Re: Case 08-15 (Wisconsin Avenue Giant Development)

ZONING COMMISSION
District of Columbia
CASE NO. 08-15
EXHIBIT NO. 130

Re: Giant PUD Commercial Truck Concerns

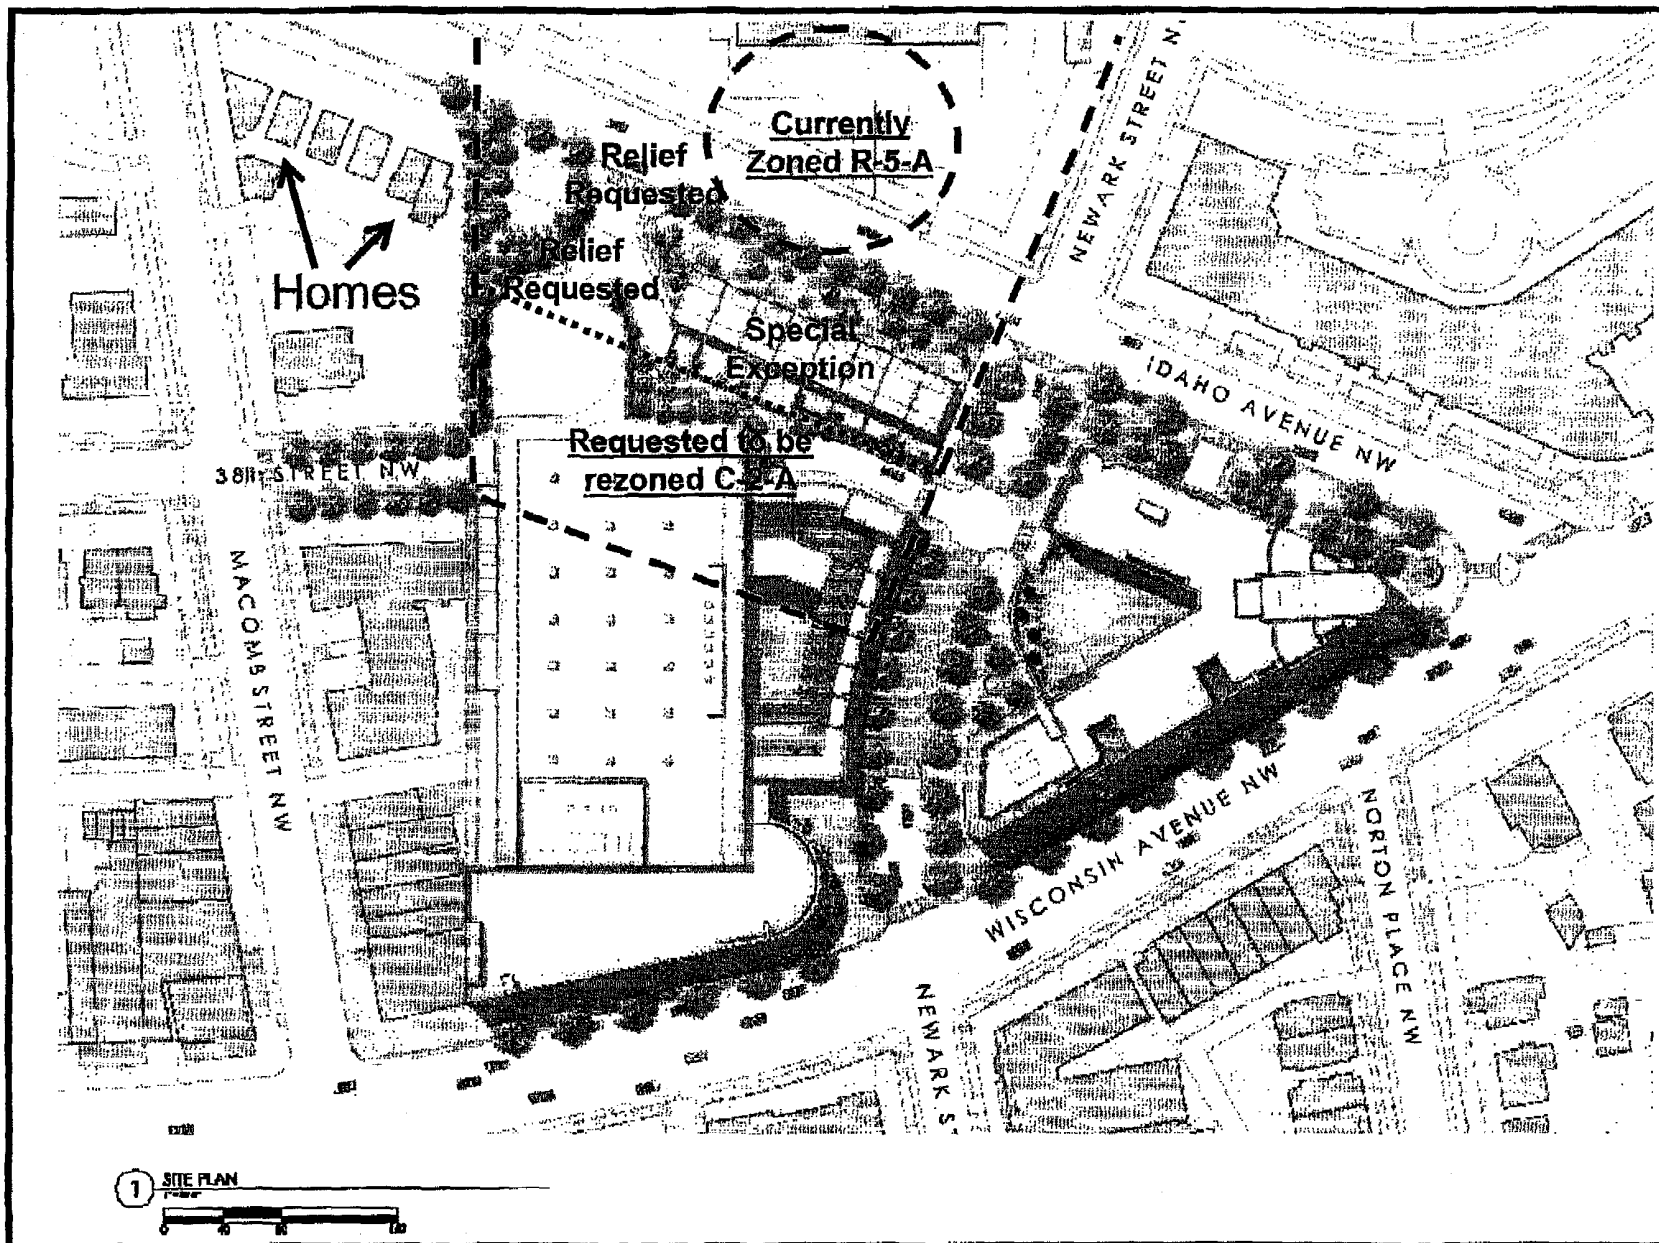
I personally observed the following situation one morning this past fall (see Picture-1): 4 Semi trucks (2 Giant, 1 Coca Cola and 1 Pepsi Cola), 1 30 foot truck and 2 smaller delivery vans parked in the Giant parking lot. These 7 trucks were all serving Giant. This event can be expected to occur in the new larger Giant store proposed loading area, with trucks and vans unloading in the turn around area. This would be in contrast to the representation that the

SITE PLAN

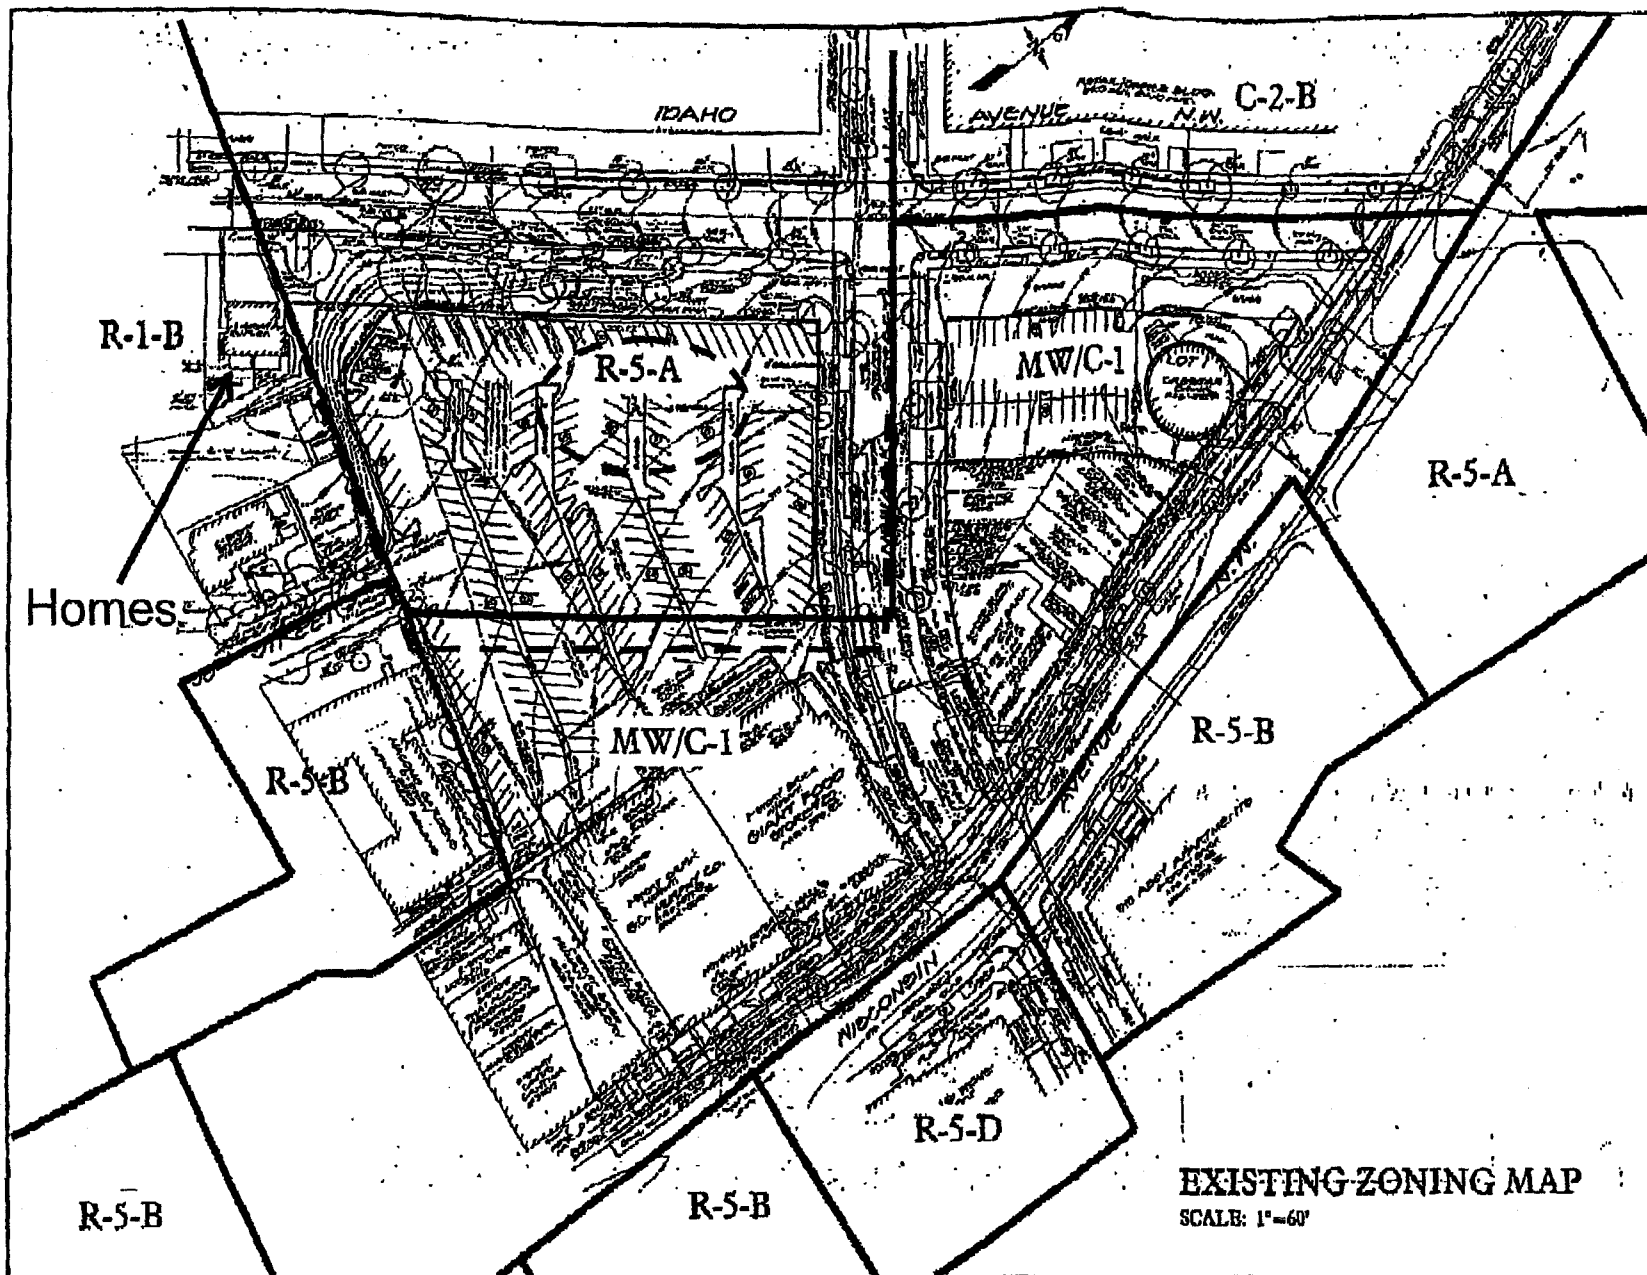
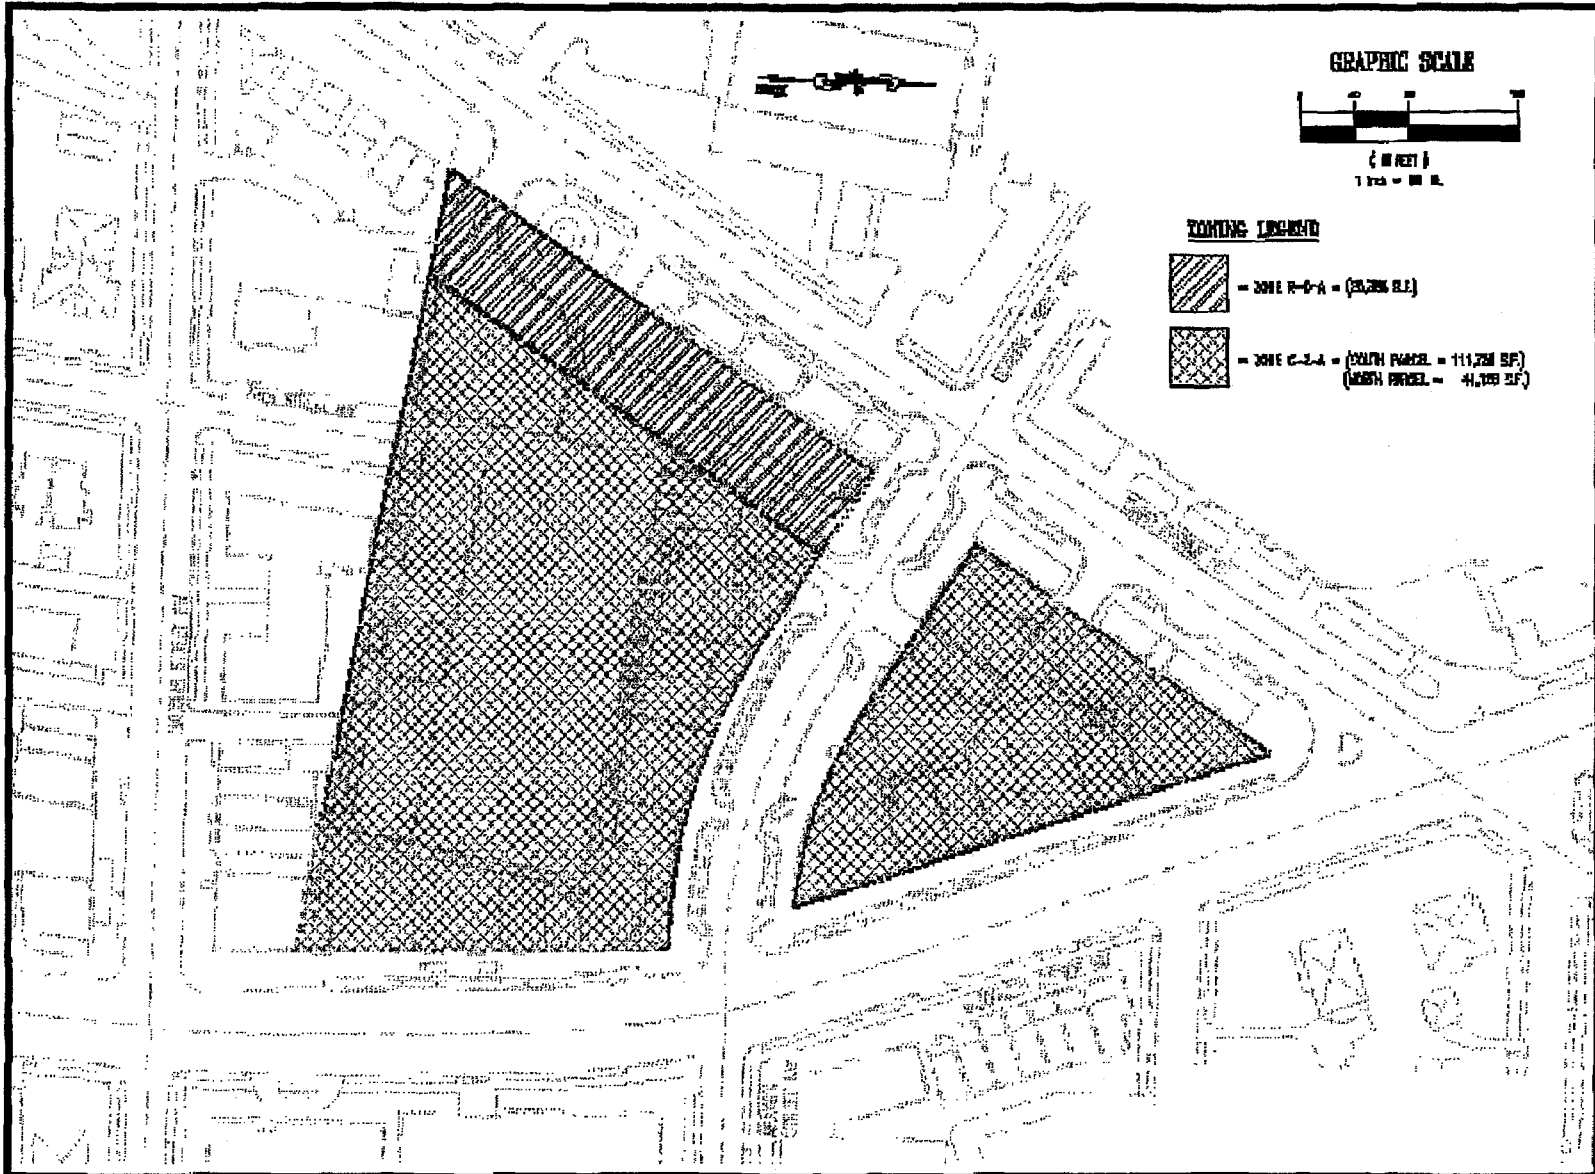
There are approximately 25,388 SF that the applicant indicates will remain in the R-5-A Zone District². In the attached Maps, I highlighted the use of the remaining R-5-A area:

- relief from the use requirements in order to permit commercial loading activity to traverse the R-5-A Zone³.
- relief for a 30-foot wide curb cut on Idaho Avenue⁴.
- special exception use to permit the Townhouses in the R-5-A Zone⁵.

In fact, there would be little true R-5-A zoning left due to special exceptions or requested relief.
